# KAMIRA AVENUE VILLAWOOD

DA:303.1/2022/KAMIRA AVENUE VILLAWOOD

RFI - DESIGN REPORT

# **DESIGN EXCELLENCE AND SEPP 65**

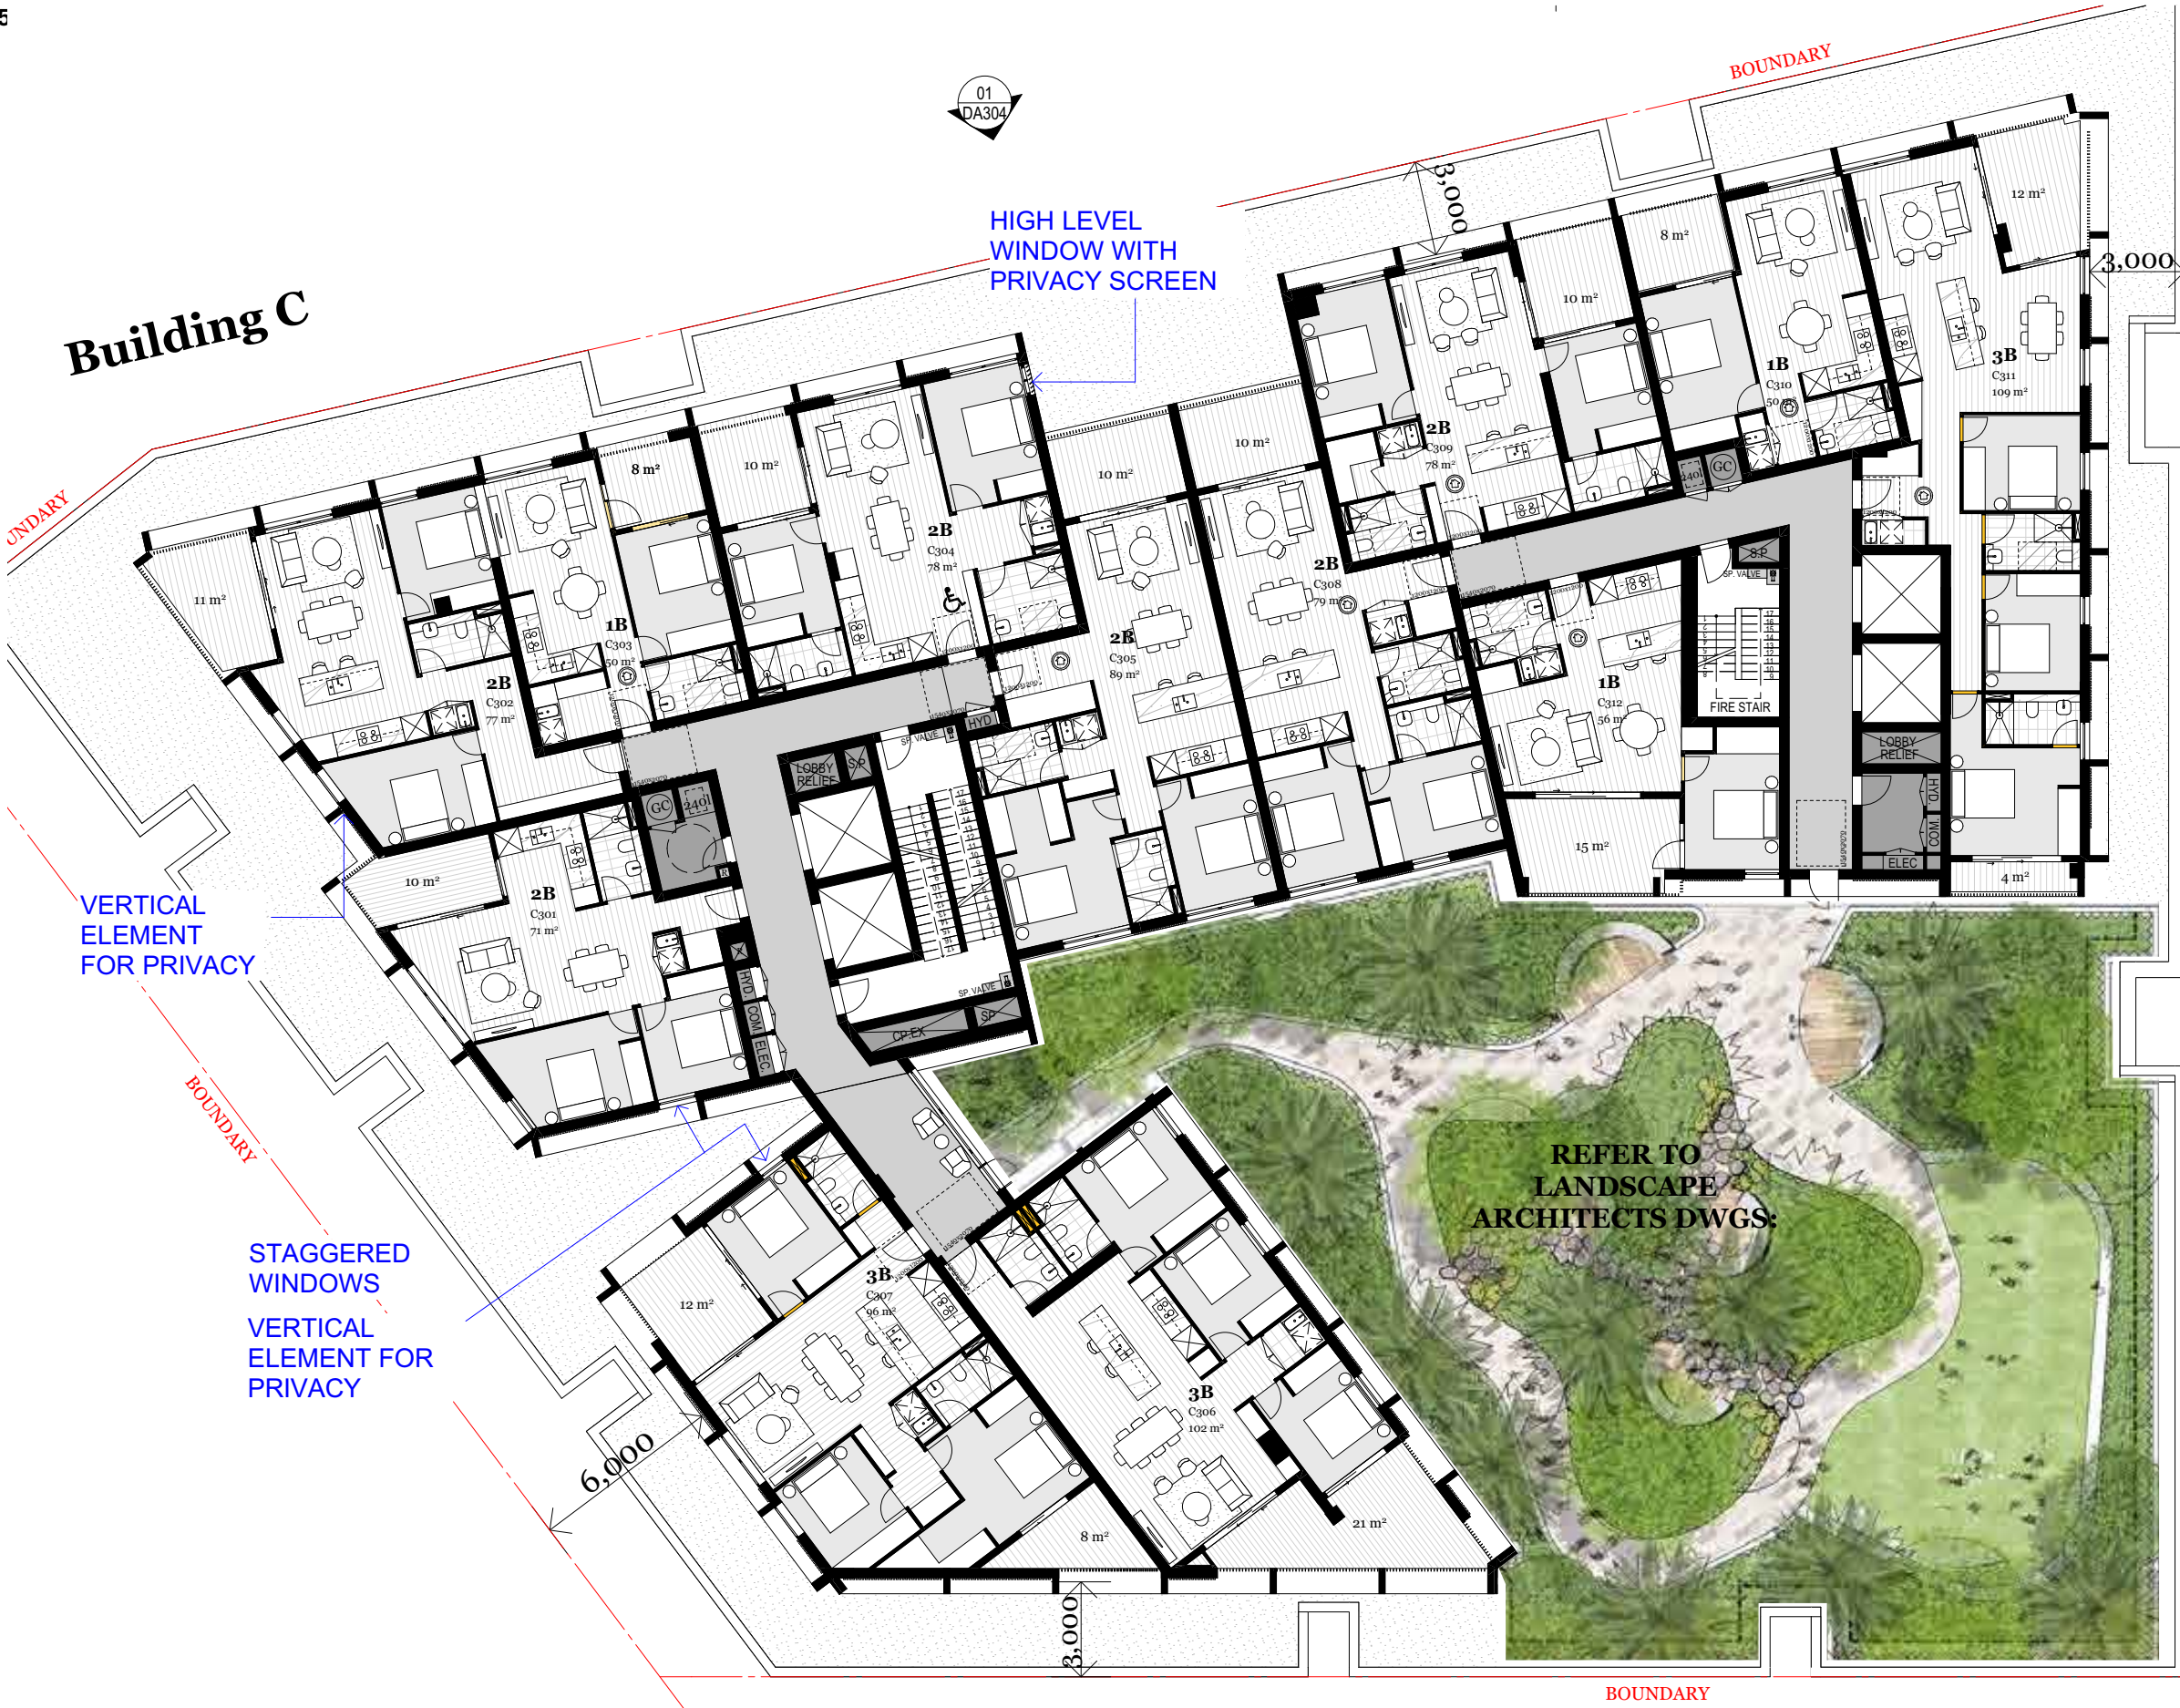
The separation between habitable spaces on the North South Laneway is less than the required ADG 12 metres. This is considered to result in privacy impacts.

This diagram illustrates that privacy impacts have been addressed by ensuring that the windows are staggered and do not directly face each other.

10 - BUILDING C PEDESTRIAN MOVEMENT TO LOBBIES

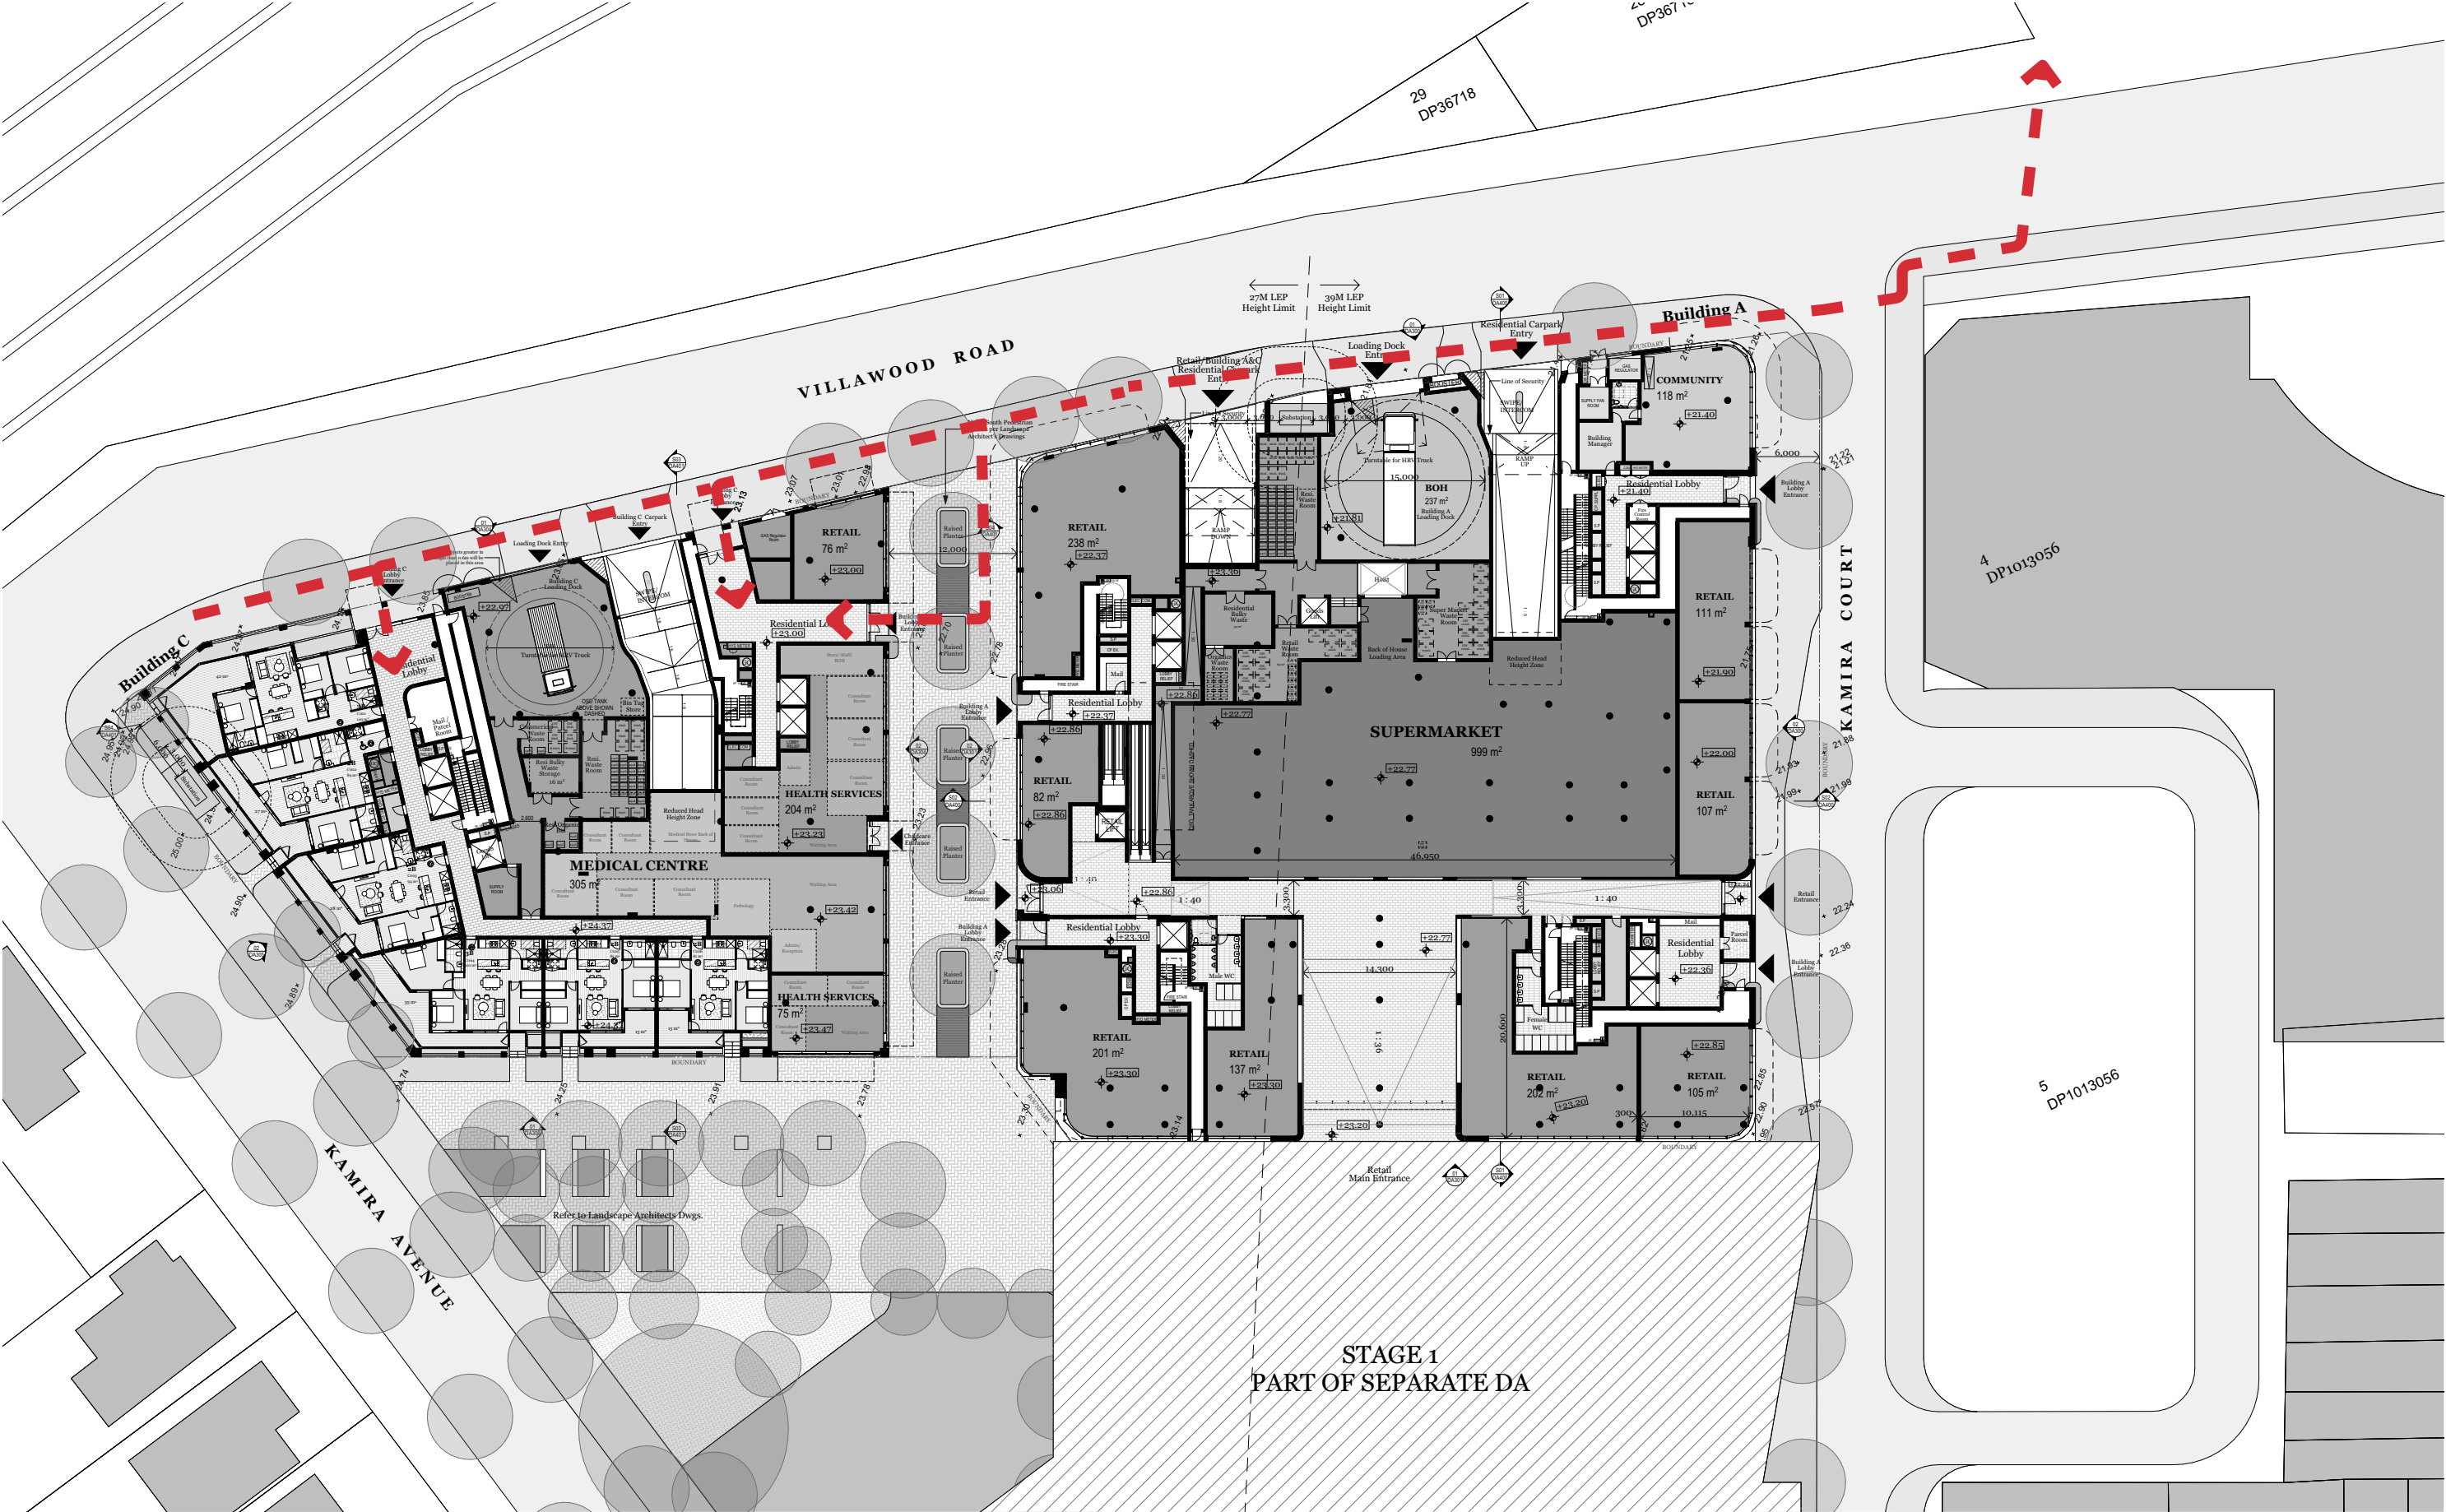
The wayfinding strategy indicates that only one address point is to be used within each for both Building A and C. This does not seem adequate as Building C has 2 main lobbies with street address and Building A 4 residential lobbies with street / plaza address. It is not clear how the practical day to day deliveries will operate for each apartment building especially considering the growing need for courier deliveries, food deliveries, pickup/drop off and visitors etc

The designated parcel rooms in each building. All parcel deliveries will be securely stored in these rooms for residents to access and collect.

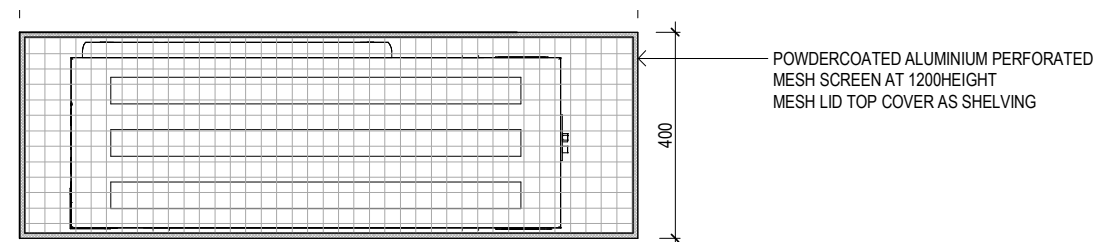
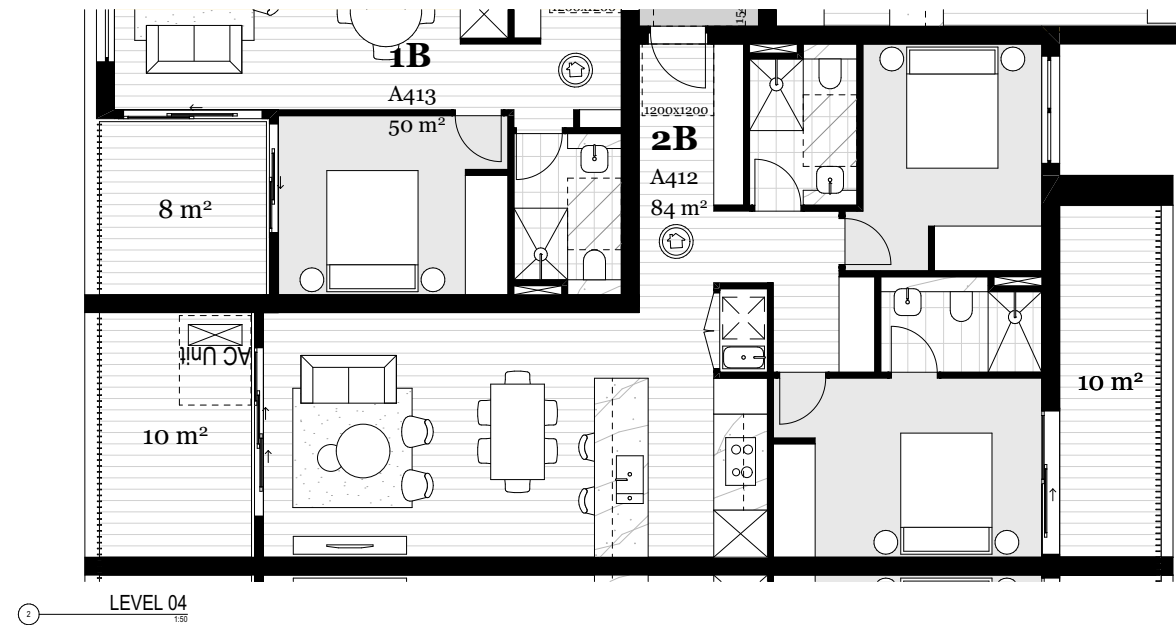
Most of the balconies just meet the minimum size as required in the ADGs. There is no clear location for AC or clothes drying identified on the plans. It is recommended that this be clarified as balconies are to meet minimum ADG areas separately to AC.

The proposal incorporates pre determined location points and encasing design responses for A/C units on balconies. The location of the integrated units on the balconies are illustrated in the plans.

- All units are to be located on the floor of the private balconies, with no units hung from the walls.
- All units are located against the rear walls of the balconies to minimize their presence when viewed from the street, to ensure that they provide a functional addition to the balcony, and to maximise the balcony space for usable private open space.

- The units comprise powdercoated aluminium perforated mesh screen to a height of 1200mm. The coloured mesh screens the plant and integrates into the balcony design (as set out in the ADG)..
- The enclosure is fitted with a mesh lid top cover that provides a functional shelf to the balcony that allows for items such as a pot plant.
